Project/File: CUP12-00046
 This is a conditional-use application to construct a 46,627 square foot events center and alumni office for Boise State University. The site is located at 1173 W. University Drive in Boise, Idaho.

Lead Agency: City of Boise
Site address: 1173 W. University Drive

DRAFT

Site Plan

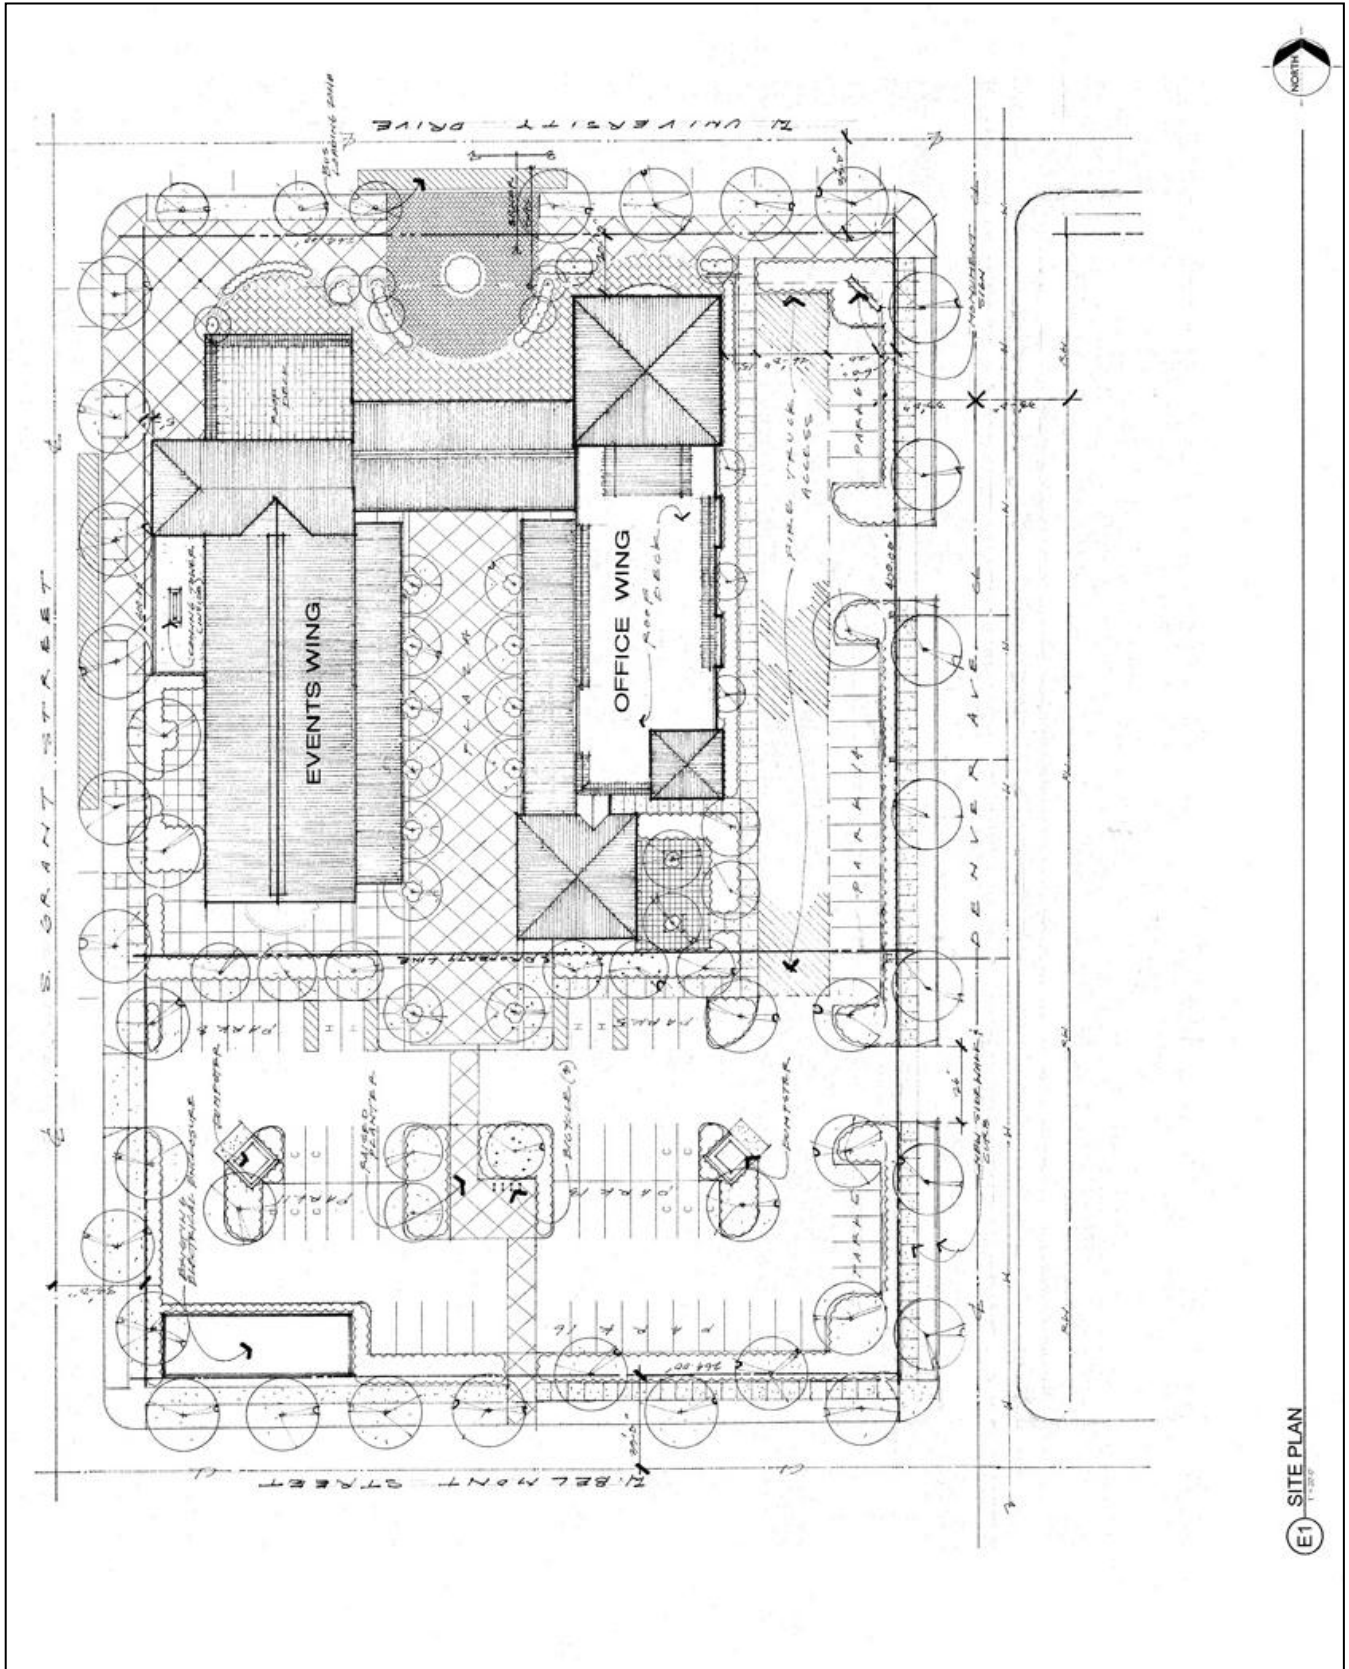
- c. **Applicant Proposal:** The applicant is not proposing any improvements to University Drive, abutting the site.
- d. **Staff Comments/Recommendations:** University Drive is fully-improved and meets the requirements of a Traditional Neighborhood Collector; therefore, no additional improvements or right-of-way should be required with this application.

The applicant should be required to replace any deteriorated or deficient sidewalk, curb, gutter or pedestrian facilities along University Drive abutting the site, consistent with ACHD's Minor Improvement Policy 7203.3.

- c. **Applicant's Proposal:** The applicant is proposing to construct Belmont Street as one-half of a 29-foot street section with curb, gutter, and 5-foot wide detached sidewalk abutting the site.
- d. **Staff Comments/Recommendations:** The applicant's proposal does not meet District Street Section Policy and should not be approved, as proposed. The applicant should be required to construct Belmont Street as one-half of a 36-foot street section with vertical curb, gutter, and 5-foot wide concrete sidewalk, abutting the site.

This is due to the site being part of Boise State University and located directly south of Bronco Stadium. Reconfiguring the roadway with a 29-foot street section, would require the installation of no-parking signs along one side of Belmont Street. This would not only restrict parking along Belmont Street, but it can be expected that during school sessions and public events, there would be a substantial amount of prohibited parking within the no-parking zones.

- c. **Applicant's Proposal:** The applicant is proposing to construct Denver Avenue as one-half of a 29-foot street section with curb, gutter, and 5-foot wide detached sidewalk abutting the site.
- d. **Staff Comments/Recommendations:** The applicant's proposal does not meet District Street Section Policy and should not be approved, as proposed. The applicant should be required to construct Denver Avenue as one-half of a 36-foot street section with vertical curb, gutter, and 5-foot wide concrete sidewalk, abutting the site.

This is due to the site being part of Boise State University and located directly south of Bronco Stadium. Constructing the roadway with a 29-foot street section, would require the installation of no-parking signs along one side of Denver Avenue. This would not only restrict parking along Denver Avenue, but it can be expected that during school sessions and public events, there would be a substantial amount of prohibited parking within the no-parking zones.

- c. **Applicant's Proposal:** The applicant is proposing to construct Grant Avenue as one-half of a 29-foot street section with curb, gutter, and 5-foot wide detached sidewalk abutting the site.
- d. **Staff Comments/Recommendations:** The applicant's proposal does not meet District Street Section Policy and should not be approved, as proposed. The applicant should be required to construct Grant Avenue as one-half of a 36-foot street section with vertical curb, gutter, and 5-foot wide sidewalk, abutting the site.

This is due to the site being part of Boise State University and located directly south of Bronco Stadium. Reconfiguring the roadway with a 29-foot street section, would require the installation of no-parking signs along one side of Grant Avenue. This would not only restrict parking along Grant Avenue, but it can be expected that during school sessions and public events, there would be a substantial amount of prohibited parking within the no-parking zones.

- c. **Applicant's Proposal:** The applicant is proposing to close all 3 driveways and replace them with curb, gutter, and 5-foot wide detached sidewalk.
- d. **Staff Comments/Recommendations:** The applicant's proposal meets District Driveway Policy and should be approved, as proposed.

- c. **Applicant's Proposal:** The applicant is not proposing any changes to the 28-foot wide driveway onto Denver Avenue located 150 feet south of the intersection of Denver Avenue and University Drive.

The applicant is proposing to construct a 26-foot wide driveway onto Denver Avenue located 135 feet north of the intersection of Denver Avenue and Belmont Street.

- c. Applicant’s Proposal:** The applicant is proposing to close the 5 driveways and replace them with curb, gutter, and 5-foot wide detached sidewalk.

The applicant is proposing to construct one 26-foot wide driveway located approximately 135 feet north of the intersection of Grant Avenue and Belmont Street (measured centerline-to-centerline).

1. Construct Belmont Street as one-half of a 36-foot street section with vertical curb, gutter, and 5-foot wide detached concrete sidewalk abutting the site.

2. Construct Denver Avenue as one-half of a 36-foot street section with vertical curb, gutter, and 5-foot wide detached concrete sidewalk abutting the site.

3. Construct Grant Avenue as one-half of a 36-foot street section with vertical curb, gutter, and 5-foot wide detached concrete sidewalk abutting the site.

4. Provide the District with a permanent right-of-way easement for any portion of sidewalk located outside of the right-of-way.
5. Replace the following driveways onto Belmont Street with vertical curb, gutter, and 5-foot wide detached concrete sidewalk to match the required improvements on either side:

- 18-foot wide driveway located 60 feet west of the intersection of Belmont Street and Denver Avenue
 - 18-foot wide driveway located 135 feet west of the intersection of Belmont Street and Denver Avenue

- 14-foot wide driveway located 135 feet west of the intersection of Belmont Street and Denver Avenue
6. Construct a 26-foot wide driveway onto Denver Avenue located 135 feet north of the intersection of Denver Avenue and Belmont Street, as proposed.

7. Replace the following driveways onto Grant Avenue with vertical curb, gutter, and 5-foot wide detached concrete sidewalk to match the required improvements on either side:

- 24-foot wide driveway located 170 feet south of the intersection of Grant Avenue and University Drive
 - 60-foot wide driveway located 250 feet south of the intersection of Grant Avenue and University Drive

- 16-foot wide driveway located 115 feet north of the intersection of Grant Avenue and Belmont Street
 - 16-foot wide driveway located 95 feet north of the intersection of Grant Avenue and Belmont Street

- 16-foot wide driveway located 70 feet north of the intersection of Grant Avenue and Belmont Street
8. Construct a 26-foot wide driveway onto Grant Avenue located 135 feet north of the intersection of Grant Avenue and Belmont Street, as proposed.

9. Direct lot access is prohibited to University Drive.
10. Payment of impacts fees are due prior to issuance of a building permit.
11. Comply with all Standard Conditions of Approval.
